Drawing Amendments

Applic, No. 10/717,415 Reply top Office Action dated 11/27/2007 Amendment dated 12/13/2007 Annotated Sheet

FIG. 2

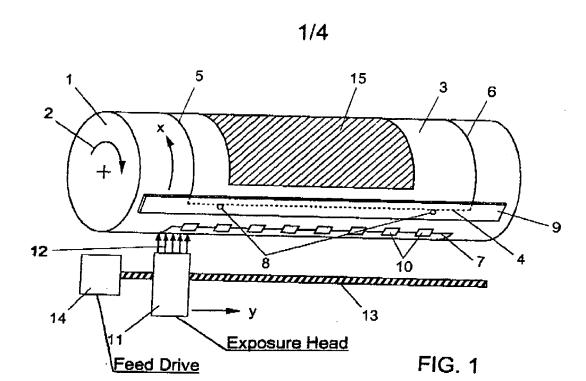
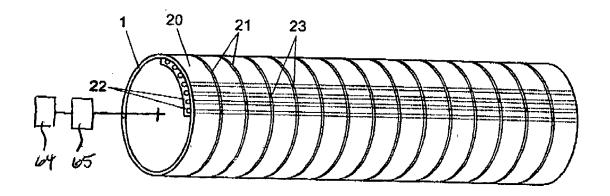
This sheet which includes Figs. 1 and 2, replaces the original sheet including Figs. 1 and 2. In Fig. 2, previously omitted vacuum pump and rotary lead through were added and designated with the reference symbols "64" and "65" respectively.

Please approve the drawing changes that are marked in red on the accompanying "Annotated Sheet Showing Changes" of Fig. 2. A formal "Replacement Sheet" of amended Fig. 2 is also enclosed.

More specifically, the Examiner has stated that the vacuum pump recited in claim 1 must be shown or cancelled from the claims.

On page 2 of the Office action the Examiner stated that one possibility for a new Fig. 2 would include a box labeled "64" connected by a line to a box labeled "65" connected by a line to the exposure drum 1. This was confirmed in a telephone conversation with Examiner Morrison on December 12, 2007. Fig. 2 has been changed so as to reflect the above-noted recommendation by the Examiner. Therefore, the objection to the drawings by the Examiner has been overcome.
